ALERT SERVICE BULLETIN

407-16-114

**SUBJECT:** ENGINE, COMBUSTION ASSEMBLY - INSPECTION OF OUTER COMBUSTION CASE P/N M250-10404

M250-C28 Series	CEB A-72-2218
M250-C30 Series	CEB A-72-3303
M250-C47 Series	CEB A-72-6085
M250-C40B	CEB A-72-5070
M250-C47E Series	CEB A-72-7002

Examples of Weld Sizes for Recurring Inspection  
FIG. 2

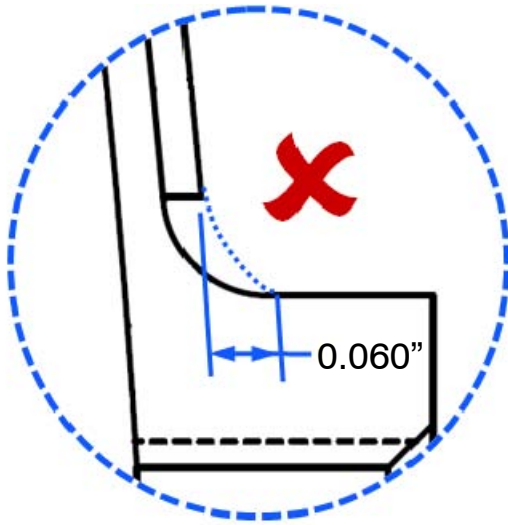
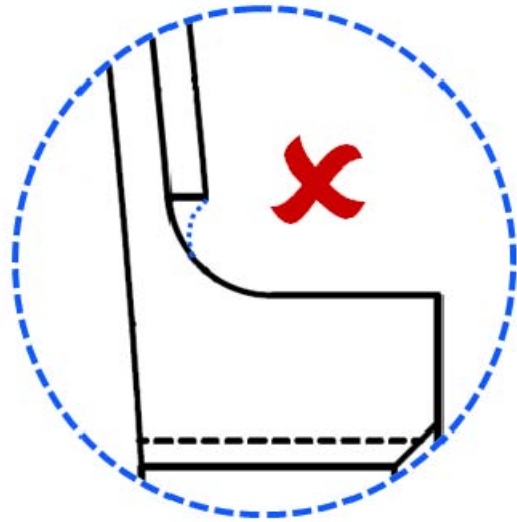
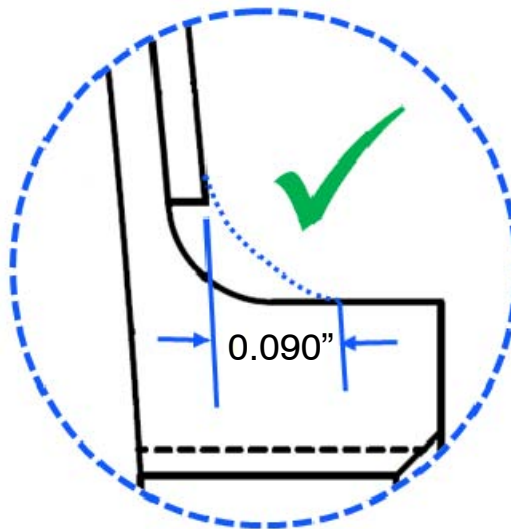
**NOTE:** Additional clarification on the acceptance criteria is shown in [Fig. 2](#). The figure contains examples of weld sizes and can be used as a guide to interpret the measurement requirements. The figure does not provide accept or reject criteria.

Requires repetitive inspection

Requires repetitive inspection

Weld Acceptable  
Return to OMM Inspection Criteria

Visual Inspection Areas of the Combustion Case  
FIG. 3

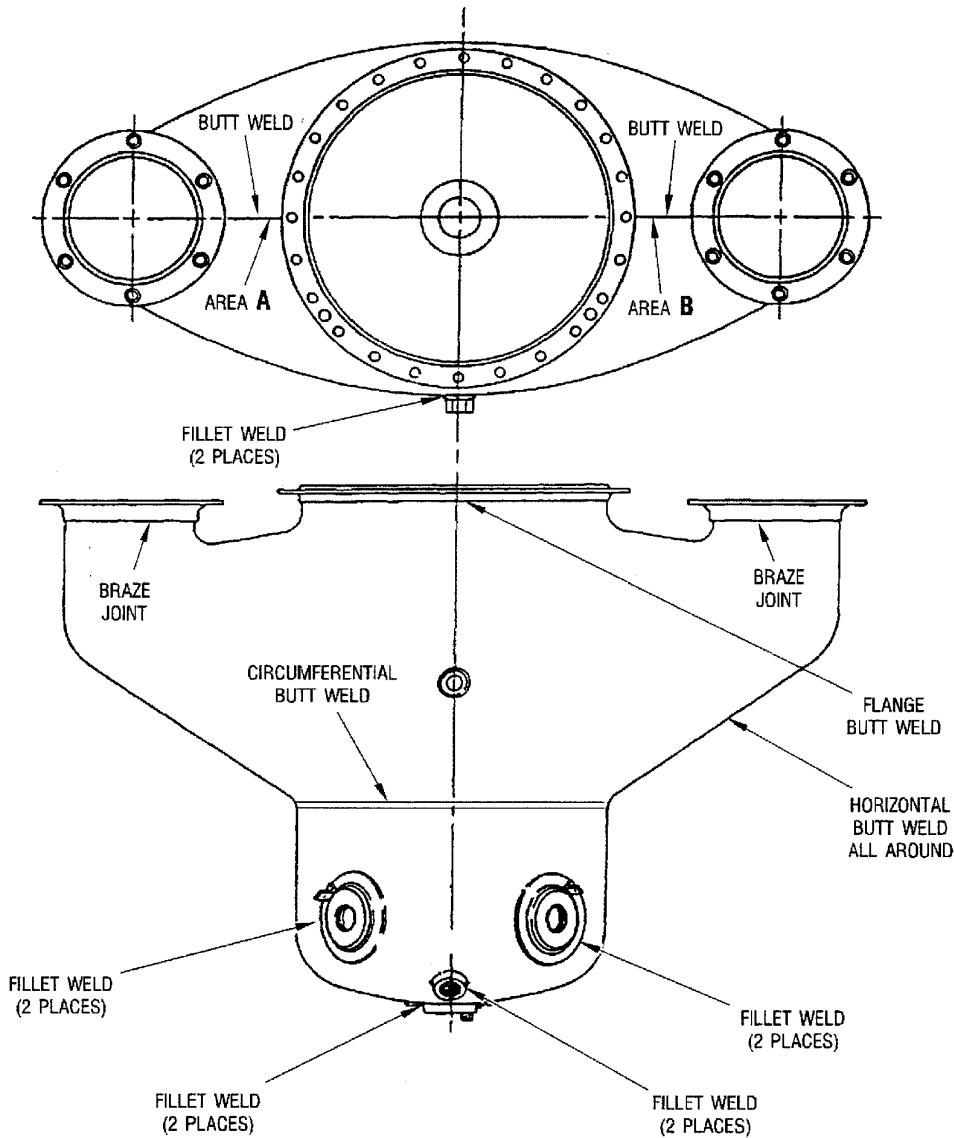
- (1) With a bright light (flashlight or equivalent) and mirror, inspect all the welds on the OCC (see
- [Fig. 3](#)
- ). No cracks are allowed. An outer combustion case that is cracked must be removed from service and repaired. Welded areas are:

- (a) Horizontal butt welds on outer surface and between the air discharge tube attachment flanges and gas producer attachment flange on forward side.
- (b) Both forward and aft circumferential seam welds between outer case and inner liner.
- (c) Welds for attaching bosses for fuel nozzle, both combustion case drain valves, both igniter plugs.

**NOTE:** Pay particular attention to the welds in areas that surround the threaded fuel nozzle boss.

- (2) With the Leak-Tec (step 2.B.(2)(a)) or fluorescent penetrant inspection (step 2.B.(2)(b)) method, inspect the above designated areas (steps 2.B.(1)(a) thru 2.B.(1)(c)). No cracks are allowed. An OCC that is cracked must be removed from service and repaired. Inspect the designated areas with one of the two methods that follow:
